# CITY OF PORTLAND, MAINE

Project Name: **Commercial Development including gas station and convenience store with ATM**  
Project ID: 2013-086 CBL: 237-A-012  
Address: 2282 Congress Street, Portland  
Joint Applicants: C J Developers, Inc. and Portland Property Holdings, LLC  
Planner: Jean Fraser

# PLANNING BOARD REPORT

Submitted to: Portland Planning Board Public Hearing Date: May 14 <sup>th</sup> , 2013	Prepared by: Jean Fraser, Planner Date: May 10 <sup>th</sup> , 2013 <b>Planning Board Report # 24-13</b>
---	--

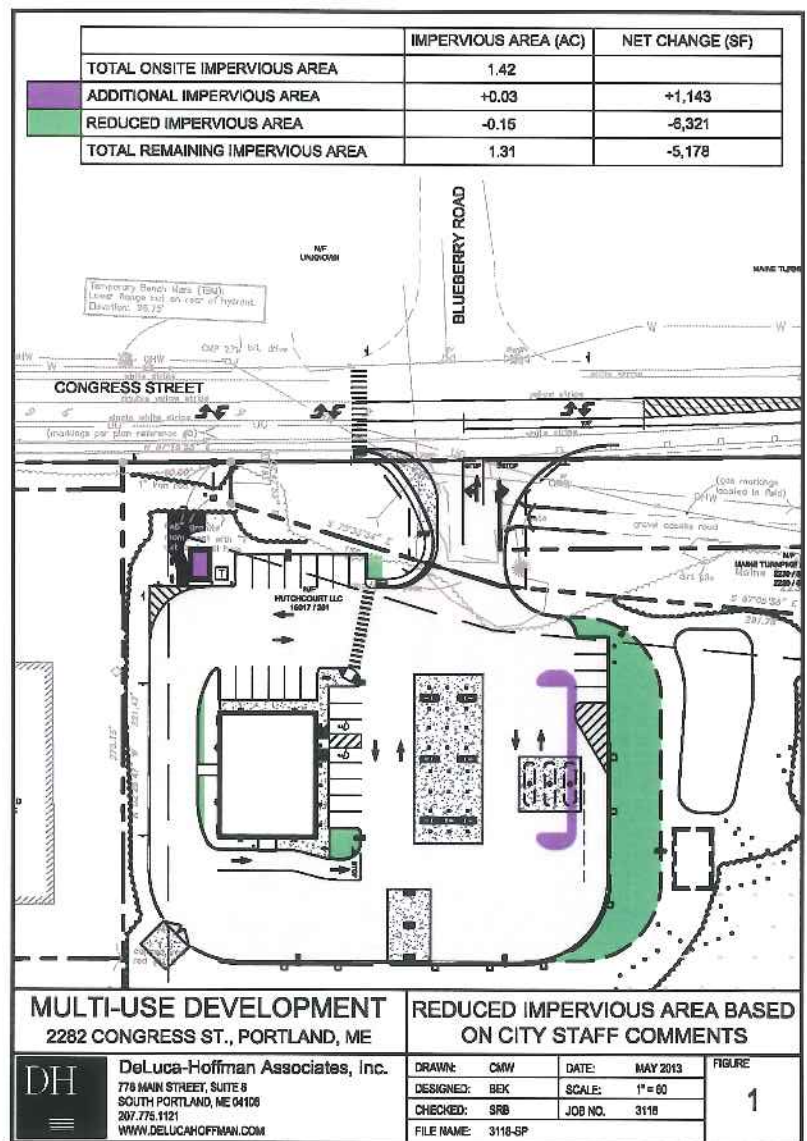
During the review staff raised concerns about the extent of the impervious surface (over 40% of the site), which was designed to accommodate maximum peak parking demand and provide ideal turning areas for very large tractor trailers. Although all of the stormwater run off would be treated, the key issue was that this created an expanse of pavement that was not consistent with the campus-like character required by the CZA.

The applicant reconsidered the parking and truck maneuvering requirements and was able to reduce the impervious area by 7% as summarized in the sketch at right.

Car parking for customers of the convenience store is now at 26 spaces, reduced from 32 spaces in the original site plan. The layout allows for the creation of parking spaces (in the green area of plan to the right) if future peak demand indicates a need for additional parking. Eight bicycle parking spaces are included and a truck parking area.
